Subject: **Submittal Supporting Accelerated ABWR Review Schedule - Suppression
Pool Bypass Paths**

Enclosed are responses to Glenn Kelly's December 22, 1992 memo to Jack Duncan
requesting clarification on the information contained in SSAR Subsection 19E.2.3.3.

Subject: Responses to Questions

19E.2.3.3 Suppression Pool Bypass Paths

Figure 19E.2-20A SMALL LOCAS OUTSIDE CONTAINMENT

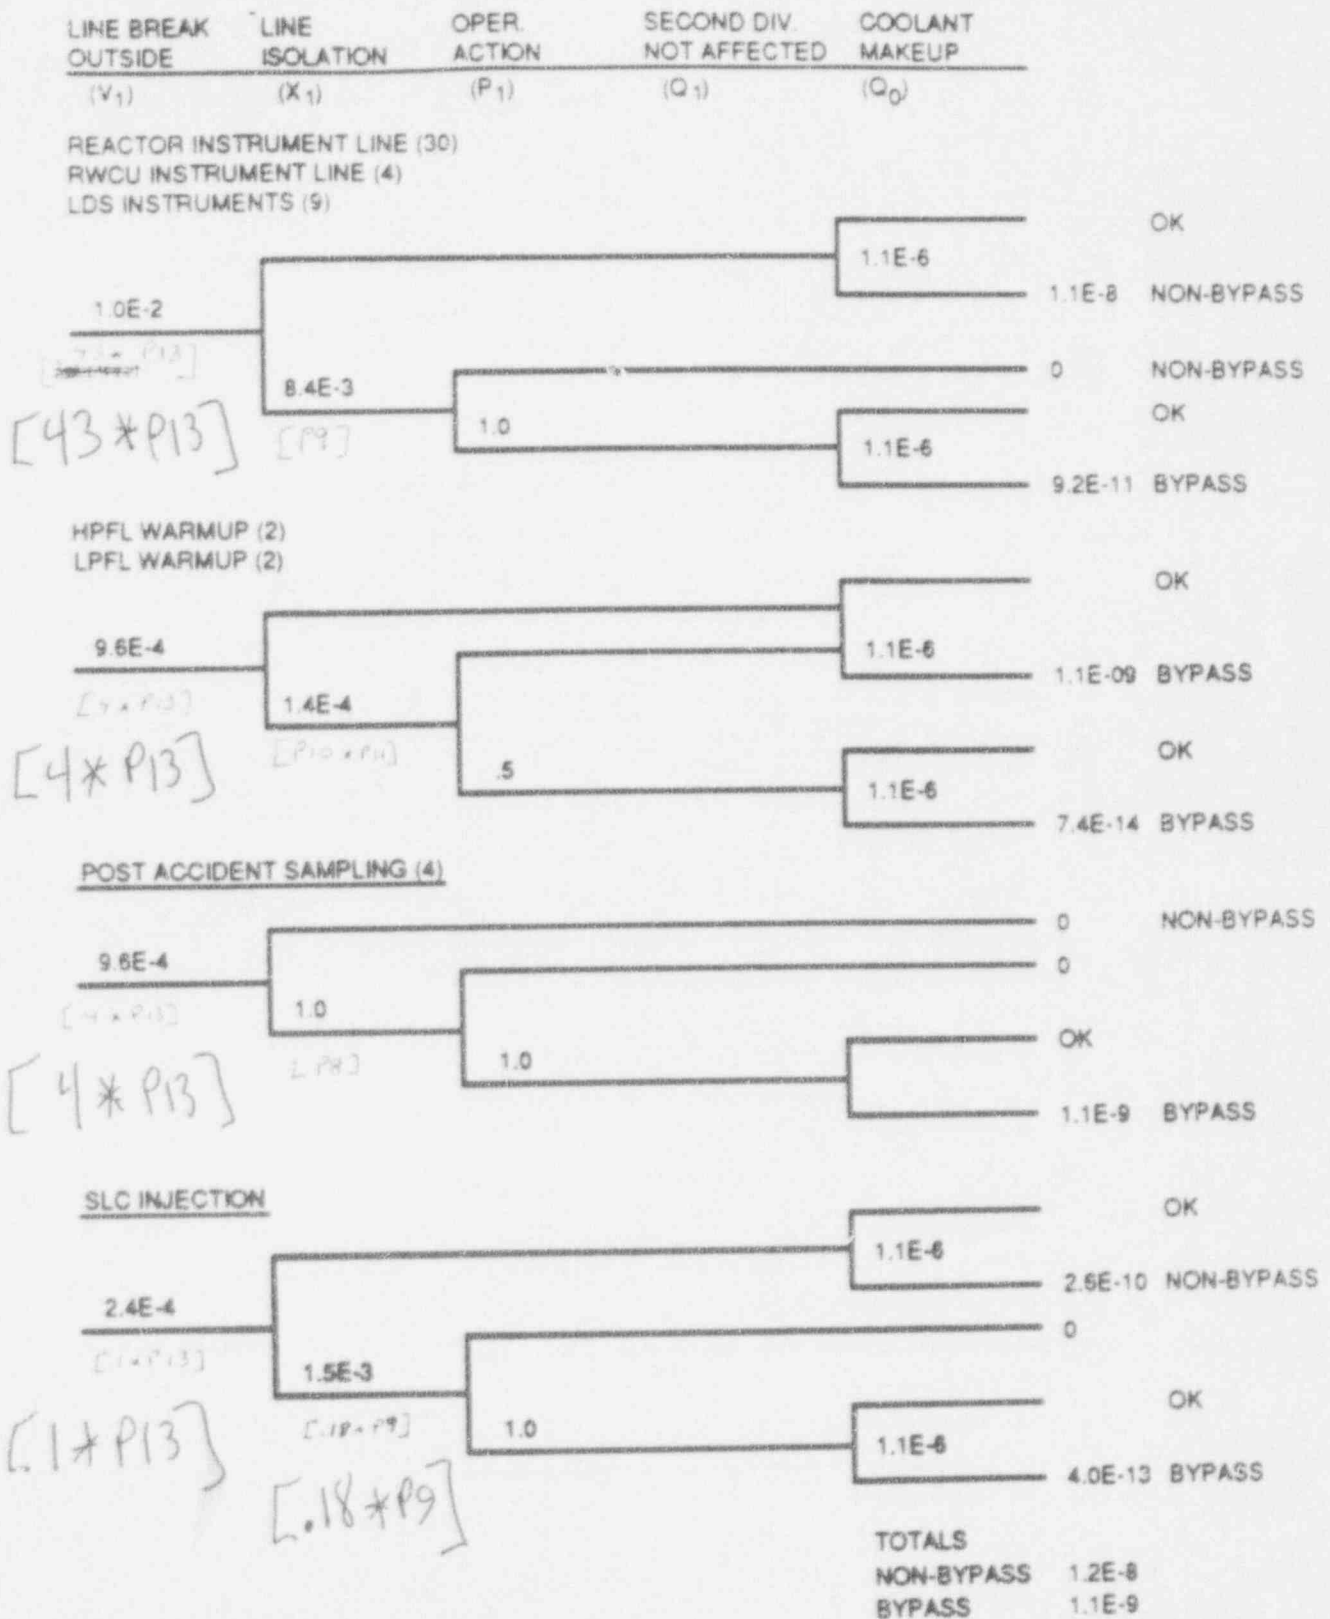
3. (a) For Figures 1, 2, and 3 in the December 17, 1992 GE draft SSAR submittal, explain how each value of X_1 is calculated. It is unacceptable merely to state that the calculation is similar to other calculations in the staff's possession, although identical calculations can be referenced.

- (b) Similarly, provide the calculations for Q_0 .

- (a) Figures 1, 2, and 3 of the December submittal are included as Figures 19E.2-20 a, b, and c in the revised section 19E.2.3.3. As indicated in section 19E.2.3.3.4, the calculation of X_1 is based on the formulas shown in Table 19E.2-21. Because the line failure probabilities were treated separately in the Figure 19E.2-20 trees, the values corresponding to the number of lines and the break probabilities (P13, P14 and P15) were not included in the values indicated. The formulas used in the event trees have been added to Figure 19E.2-20.

- (b) The basis for the values of Q_0 is provided in section 19E.2.3.3.4. The calculation of the values was accomplished by examining the ratio of core damage frequency to initiating event frequency in the PRA fault trees. Values with degraded divisions were obtained by recalculating the fault trees with the most limiting division(s) disabled. Only the results of this process were provided in Section 19E.2.3.3.4.

Fig 19E.2-20 changed

Figure 19E.2-20B MEDIUM LOCAS OUTSIDE CONTAINMENT

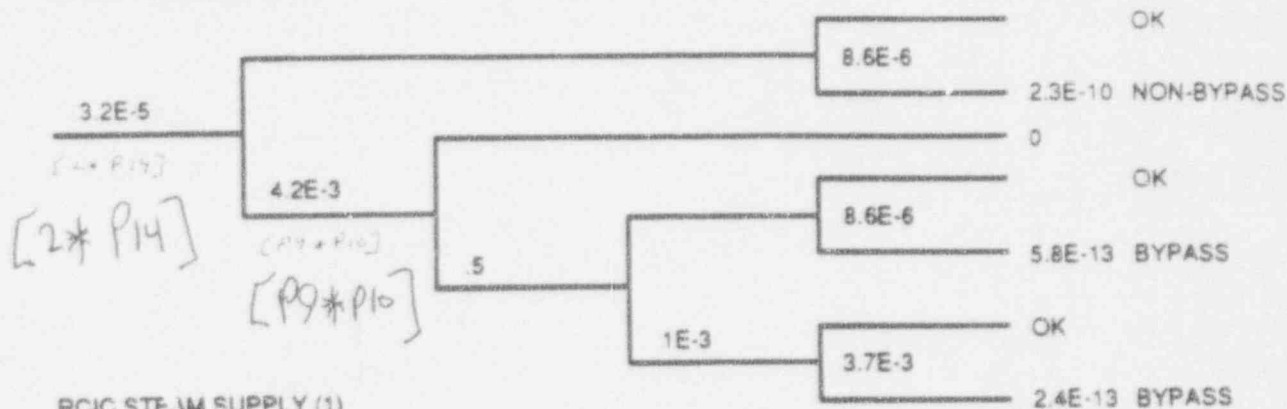
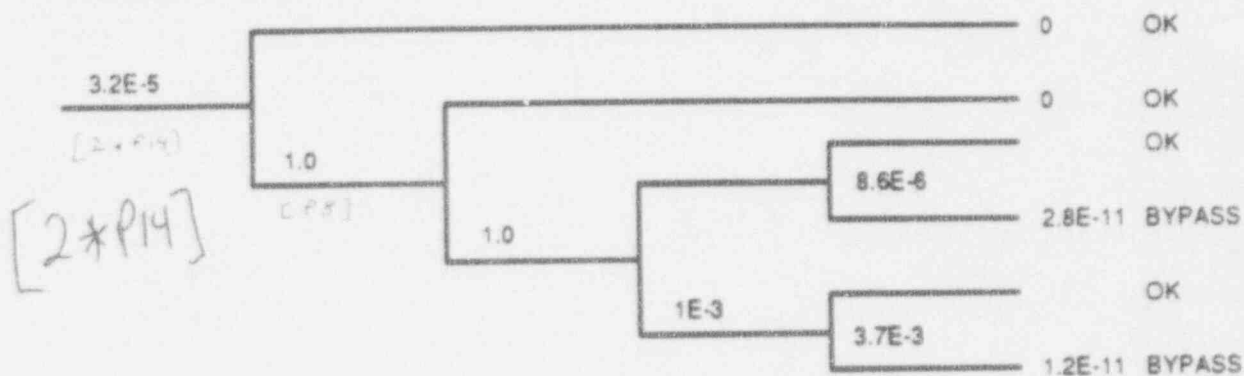
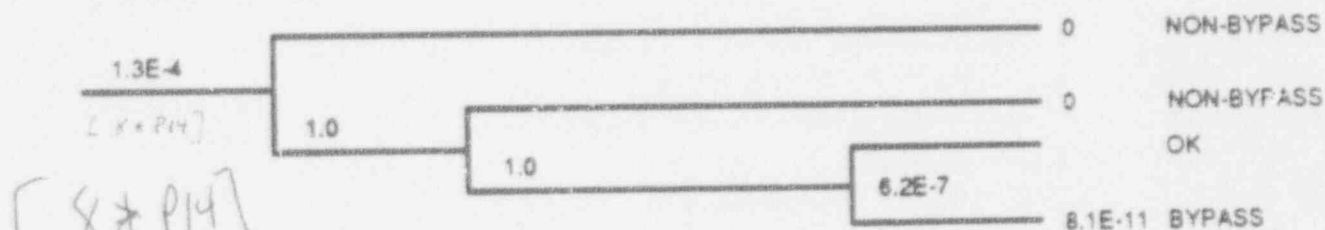
1. It appears that the value of Q_1 (failure of another division) was estimated to be $1E-3$ if the LOCA in the secondary containment occurred near another division wall.
 - (a) Please amplify on how this was determined and what was the basis for deciding which LOCAs were or were not $1E-3$ events.
 - (b) Also please explain how the values of Q_1 and Q_0 in Figure 2 (Medium LOCA Outside of Containment) were determined.

- (b) The values of Q_1 in figure 2 (now Figure 19E.2-20B) was based on engineering judgement as discussed in the response above. The Value of Q_0 is indicated in a table included with the discussion of Q_0 in section 19E.2.3.3.4 for medium size LOCAs. The development of the tree shows the loss of divisions assumed.
